Textown Ltd (Extension building)

Dewan Idris Road, Bara Rangamatia, Ashulia, Dhaka.
(23.911180, 90.301861)

23rd Sept 2020

Lack of water proofing & water ponding

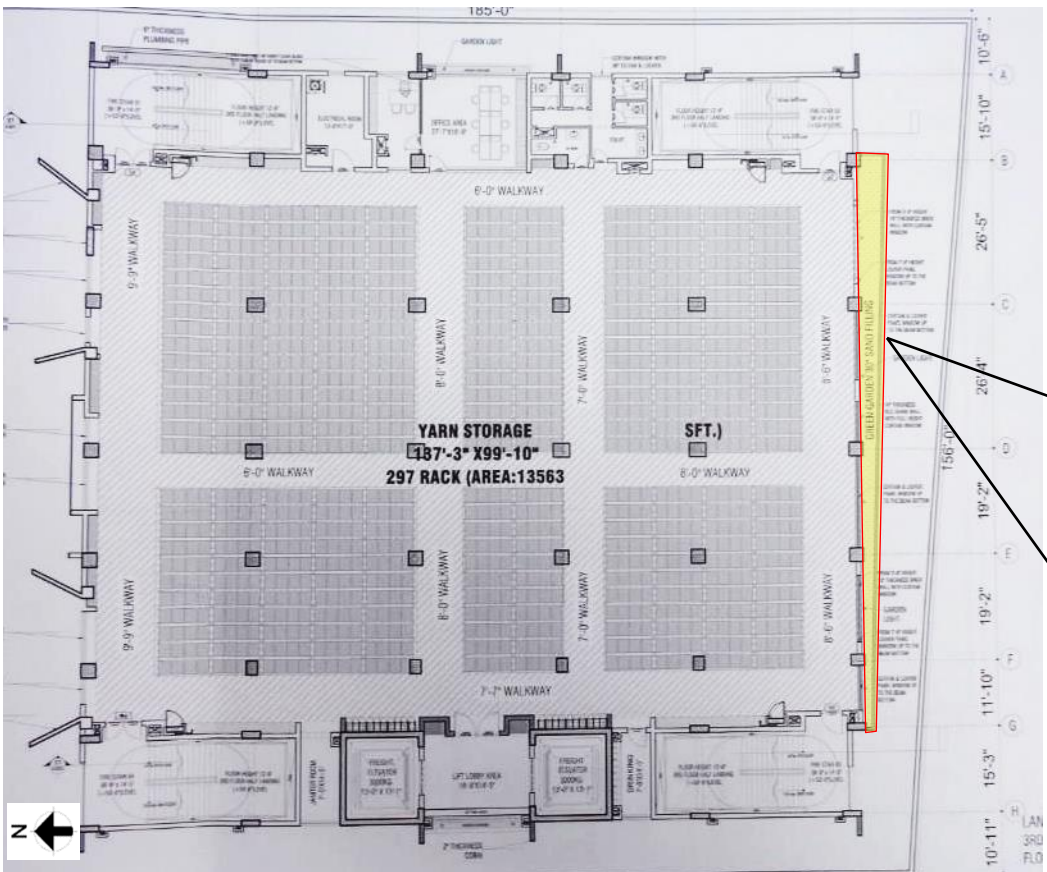
Water ponding was found at roof due to lack of water proofing with proper slope. The factory engineer to apply proper water proofing layer with proper slope on the top of roof slab to resist water ponding.
